## Addendum # 1      Bid # 2020-1A

### South Hadley Electric Light Dept IFB for the Telecom Substation Improvements

#### July 27<sup>th</sup> Questions and Answers

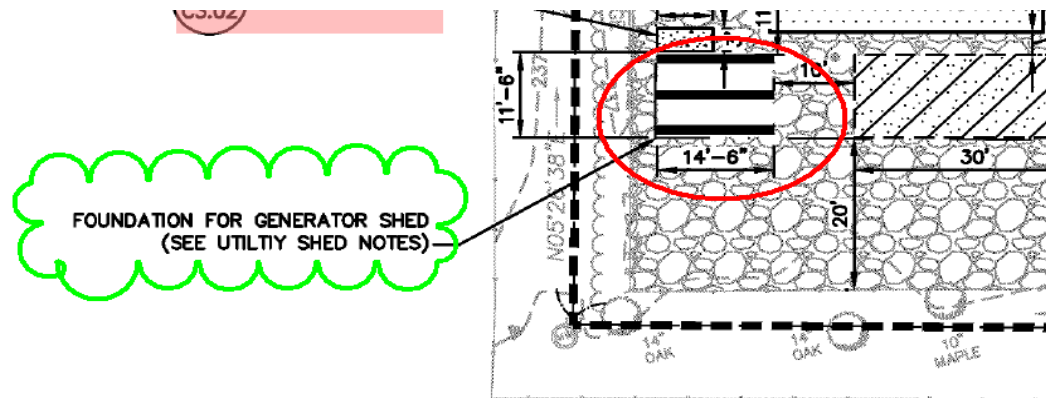
- 9) On Sheet C1.20 for the Old Lyman Road site there is a foundation for generator shed (see utility shed notes). What are the foundation requirements for this pad? Would it follow the 2/C3.02 pad detail? Location is circled below:

**Contractor should use the same plan and spec for pad under relocated Unit 2 and keep overall dimensions indicated on plan set.**
